Department of Planning and Zoning

TO: Development Review Board
FROM: Scott Gustin 
DATE: July 15, 2014
RE: 14-1206SP; 380 Colchester Avenue

Request: Sketch plan review of 3-lot subdivision.

PROPOSED SKETCH PLAN

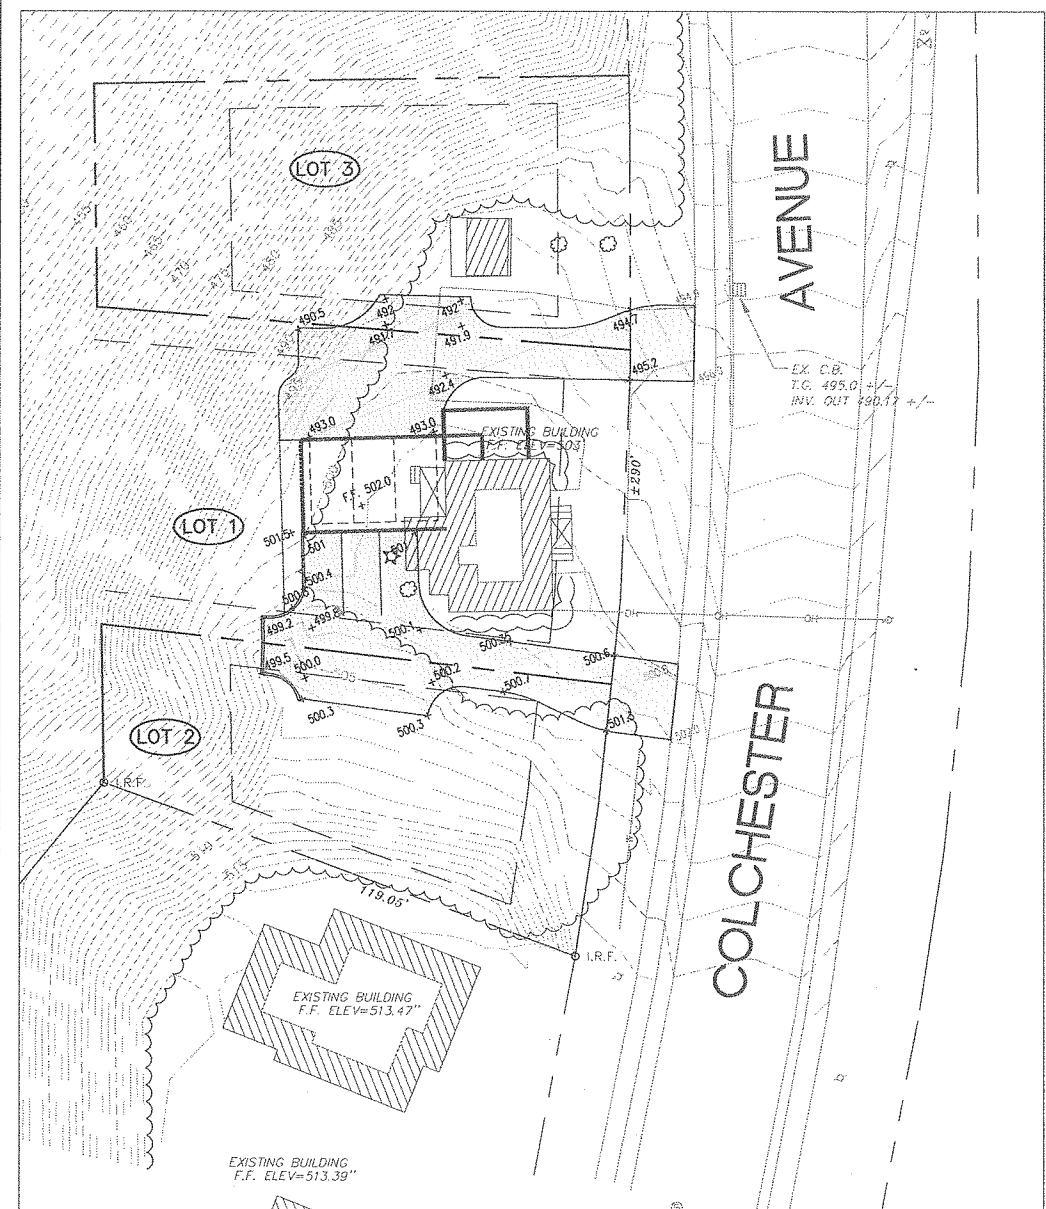
The sketch plans depict two shared driveways. This configuration reduces the potential number of access points along Colchester Avenue. The proposed curb cuts will need review and approval by the Department of Public Works. Sight lines will be particularly important in this location.

Building envelopes are depicted on the two new vacant lots, lots 2 and 3. Compliant front, side, and rear yard setbacks are depicted. The shared driveways are depicted along shared lot lines and are allowed per 5.2.5, *Setbacks*, (b) *Exceptions to Yard Setback Requirements*, 6.

No new lot coverage is included in this proposal. Lot coverage on lot 1 obviously remains compliant; however, no actual lot coverage calculation has been provided. One will be needed upon subdivision review.

The subdivision itself will have no impact on important natural features. The proposed building envelopes depict where development may take place. The building envelope on lot 2 largely avoids the steep slope to the west. Quite to the contrary, much of the building envelope on lot 3 extends over the steep slope. As required for the neighboring subdivision at 366 Colchester Avenue, the building envelope on lot 3 should be revised to avoid all or most of the slope to the west.

(d) Connectivity of streets within the city street grid
While no new streets are proposed, the new lots will access Colchester Avenue with shared driveways. Given the grades onsite and the curvature of Colchester Avenue along the properties' frontage, adequacy and safety of vehicular access onto the street is a concern. The proposed driveway locations will be subject to review and approval by the Department of Public Works.
